601-603 Saluda Avenue

DESIGN/DEVELOPMENT REVIEW COMMISSION
DESIGN REVIEW DISTRICT
HISTORIC AGENDA
EVALUATION SHEET
Case # 1

NATURE OF REQUEST: Request Certificate of Design Approval for demolition

Summary
Structural Evaluation
of
601-603 Saluda Ave
Columbia, SC

Site issues behind duplex:

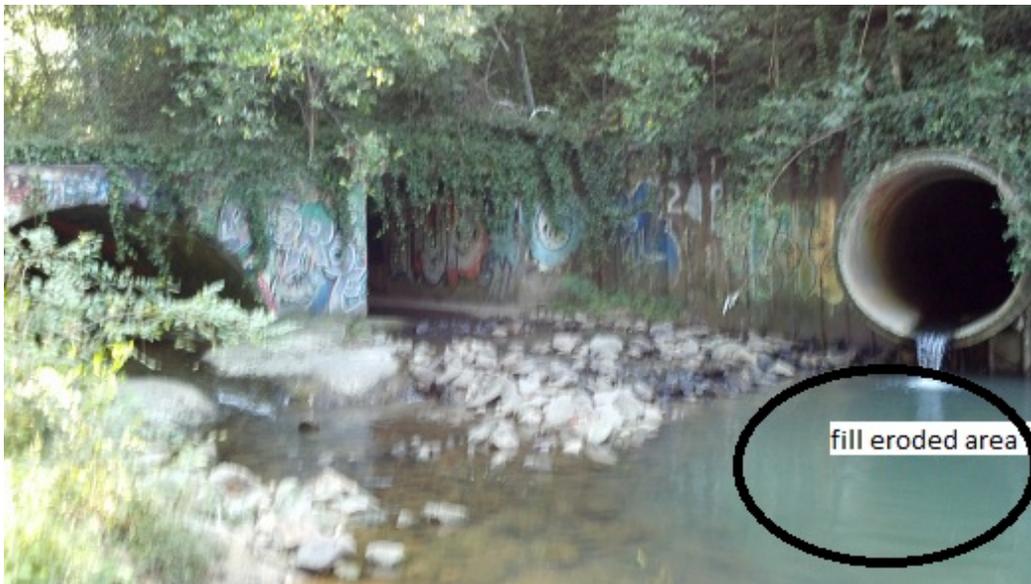
1. The area south of the outfall pipe will need to be backfilled to provide stability.

2. Sheet piling should continue from current location after backfilling.

3. Gabion Baskets should be installed to help with erosion of the opposite bank.

4. The area at the outfall of the pipe should be filled and armored.
